DEVELOPMENT SERVICES MEMORANDUM

RE: PROPOSED WALKWAY CONNECTION TO LOUGHEED ROAD (BLOCK 56)

ZONING BY-LAW AMENDMENT - 8001 COUNTY ROAD 27 DIPOCE (INNISFIL)

DATE: JANUARY 27, 2020

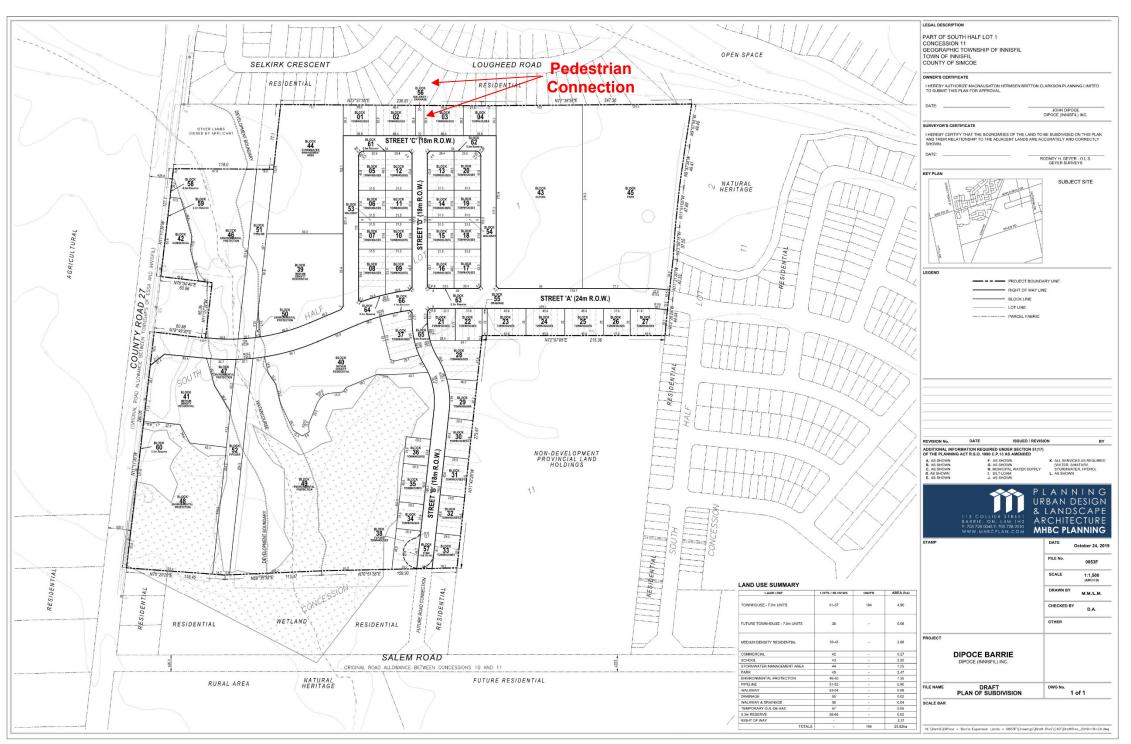
Members of Planning Committee asked if there was a connection between the proposed subdivision with the existing neighbourhood to the north. There is a proposed walkway connection from Street 'C' to Lougheed Road, identified as block 56, on the proposed Draft Plan of Subdivision (see Appendix "A").

Planning Committee asked if that proposed walkway would be maintained to the same standard as a municipal sidewalk during the winter months and trying to determine if it is a sidewalk or a walkway. Walkways are not maintained in the winter.

Planning Committee also questioned if Street 'D' and a municipal sidewalk could be extended through to Lougheed Road, rather than a pedestrian connection. In doing so, Street 'D' would be extended through 39 Lougheed Road which is owned by the City of Barrie.

Through the technical review process, City Transportation Planning staff explored the feasibility of providing a road connection between Street 'D' and Lougheed Road which is part of an existing, developed subdivision. The geometric design of the road extension was considered to be undesirable by staff. The street extension was also undesirable from a land use perspective, as it would disrupt the parcel fabric along Lougheed Road and could pose safety concerns given the proximity to existing residential driveways, as identified in the aerial photograph in Appendix "B".

To create a walkable community, City staff requested that a pedestrian connection be provided between Street 'C' and Lougheed Road to increase pedestrian connectivity in the area and promote the use of active transportation. The pedestrian connection would also provide a safe and direct link to the municipal sidewalk proposed along the outer edge of Street 'C', thereby making the park and school blocks more accessible to residents (see Appendix "C" – Pedestrian Circulation Plan).

While the connection proposed is wide, it would be considered a walkway and would not be maintained in the winter months as a municipal sidewalk. Direction on walkway winter maintenance is given in Council Motion: 98-G-72 Walkway Winter Maintenance, which states:
